Drainage Strategy – Existing Ditch Information Note for the site at Leicester Road, Earl Shilton (24/00496/REM)

Comments extracted from an email from Dave Harris of Mucklow and Harris Ltd to Andrew Smallwood of Leicestershire Lead Flood Authority.

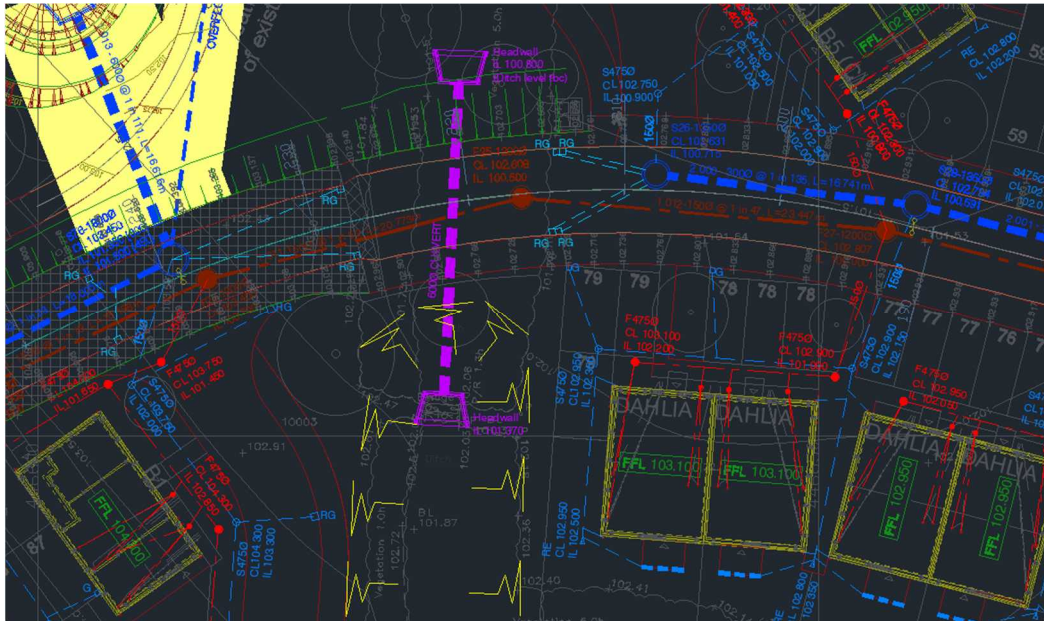
- In terms of the upstream drainage. I appreciate it is a relatively limited catchment (historical maps show there was connectivity between the fields that are now West Street, and the watercourses that enter your proposed site). You also mention that there is a pond that overflows into the watercourse.

- Presumably these older connections from further south are no longer present (seems very likely to me that the former ditches along West Street would have been incorporated into the road drainage) but wanted to clarify? – from the information we have including the RSK Flood Risk Assessment we don't believe there is any drainage from the south it appears as you say all highways and properties drain via drainage within Keats Lane and West Street.

- Has any calculation of the catchment been done? 600mm diameter culvert is sizeable, but if you have an estimate of what is expected to be in the ditch in say a 100yr event with Climate change that will be useful in demonstrating suitability. – no modelling has been done given the only flows are from the adjacent site which is limited to greenfield runoff and the existing pond which is fed by a spring so flows are likely to be negligible. We have based the 600mm diameter culvert on the estimated cross sectional capacity of the existing ditch and then gone a pipe size up.

- There are some existing levels on the plan, are the current ditch levels being maintained? There is only circa 560mm difference between the base of the existing ditch and the finished floor of the proposed houses. You also show a 150mm dia foul sewer going through the road. Are you going to have enough cover for a 600mm dia culvert? Appreciate that this is only REM stage and detailed levels haven't been confirmed. But we need to ensure that the appropriate sized culvert can be installed. If 600mm is deemed appropriate, we would not accept a future consent application for a 300mm on the grounds of that being all you can fit. – the existing ditch levels are to be maintained (the FRA does highlight some remedial works and clearing of the ditch which will be undertaken). We have approximately 1-1.2m of cover to the highway levels (see above exert from the drainage plan – we are currently doing the

- In terms of the road culvert, in a blockage or exceedance event, we would expect to see surcharged water re-entering the watercourse at the earliest opportunity and not endangering adjacent properties. Looking at existing ground levels, the eastern side is slightly lower and thus be at higher risk. I appreciate this is possibly an extremely unlikely event (unless there's additional inlets upstream) and can be easily rectified by altering site levels to encourage water to flow either over the carriageway, be picked up by road drainage or flow into the POS to the west. But if you do have any thoughts on this it would be appreciated. – as you've noted the risk of flooding is unlikely given we are proposing a 600mm diameter pipe. In the event the culvert was blocked we would expect the ditch to overtop the road and fall back into the ditch the other side as the low point. Falls to the plots to the north side of the highway are higher than the ditch levels and levels are designed to fall away from plots back towards the ditch meaning any surface water flooding are directed back towards the ditch and away from properties.

detailed design) . The proposed foul also drains under the culvert (again see extract above). With regard to the FFL as levels fall steeply away to the north it is assumed this FFL shouldn't be an issue as any surface water would fall away to the north and the proposed driveway/parking is also designed to fall away from the property towards the ditch.
